# MEMORANDUM

**DATE:** August 14, 2024
**FROM:** BAE Group
**TO:** Dungan Design Group
**RE:** Chipotle #5042 – Metairie

This is a summary of the changes included in Revision #2.

## Store No. 5042
## 6940 Veterans Memorial Blvd.
## Metairie, LA 70003

1 M100 **HVAC FLOOR PLAN**
1/4" = 1'-0"

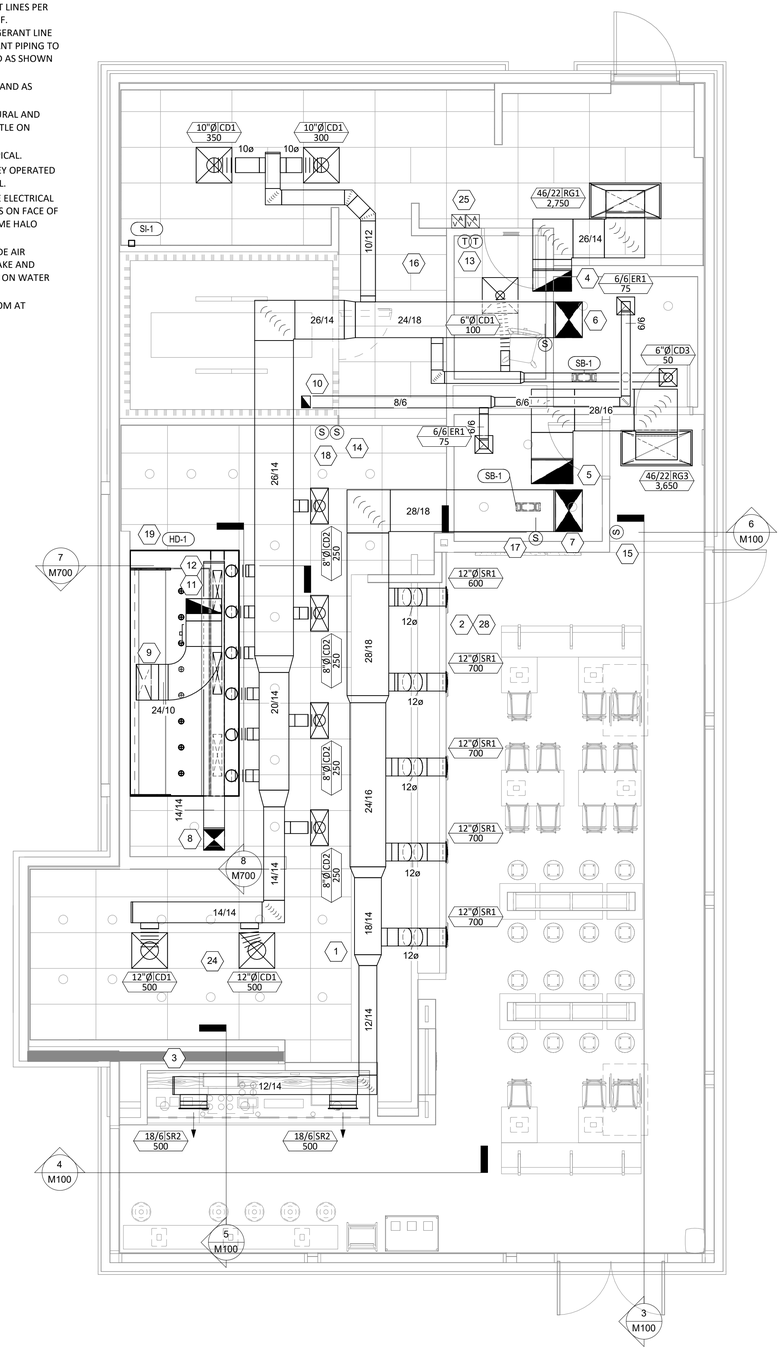
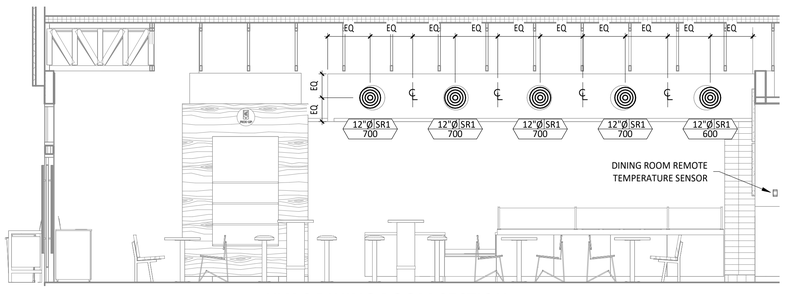
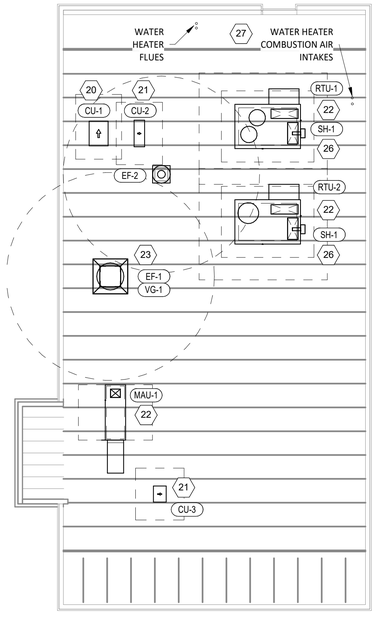
- Kitchen temperature sensor heights updated. (M100)
- Ice maker condenser models updated. (M600)

1/P100 **PLUMBING SUPPLY PLAN**
1/4" = 1'-0"

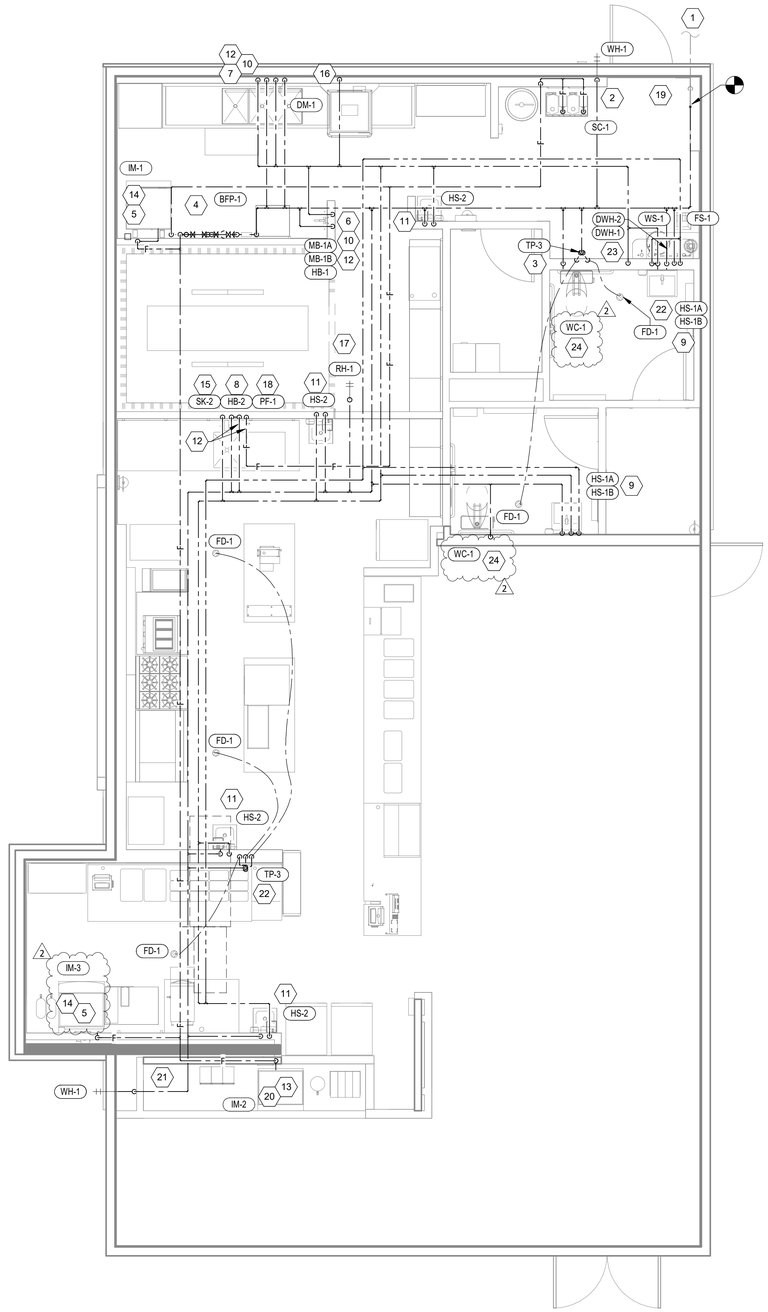
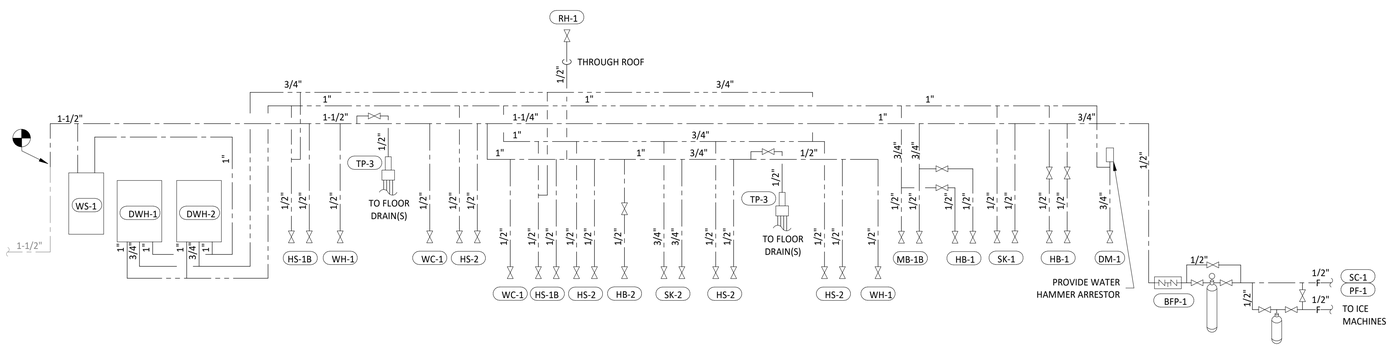
- Note added for replacement of stock water closet flush handle. (P100)
- Dish machine rough-in note updated. (P100)
- Ice maker descriptions updated. (P100 & P600)
- Restroom hand sink model updated. (P600)

## LIGHTING FLOOR PLAN

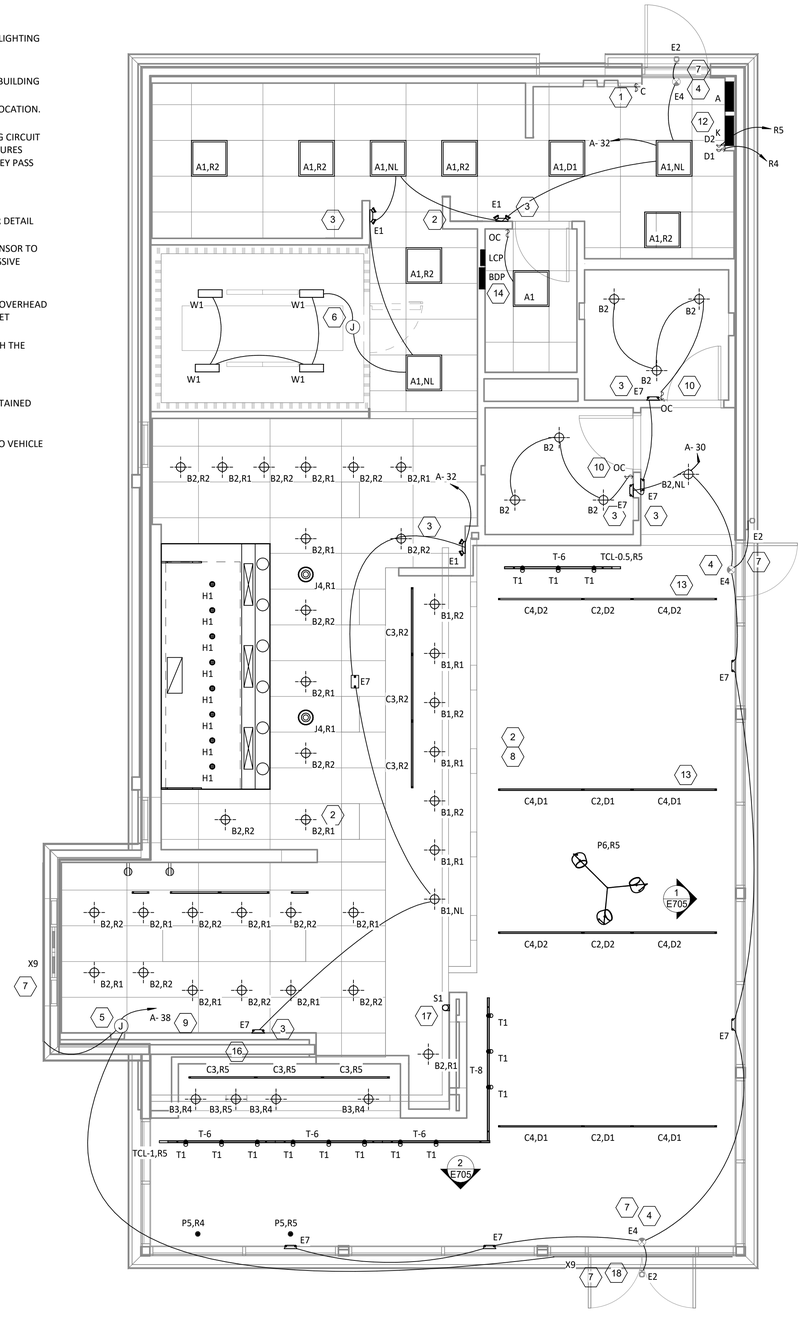
- Lighting control panel model updated. (E100)
- Security keypad re-located and door contacts added. (E010 & E110)
- Rough-in notes for fire protection and timeclock updated. (E110)
- Cell booster and lightning arrestor note updated. (E110)
- CO2 rough-in heights updated. (E110 & E710)
- Pick-up window directional note added. (E700)
- Low voltage box ring added for cell phone booster cables. (E700)
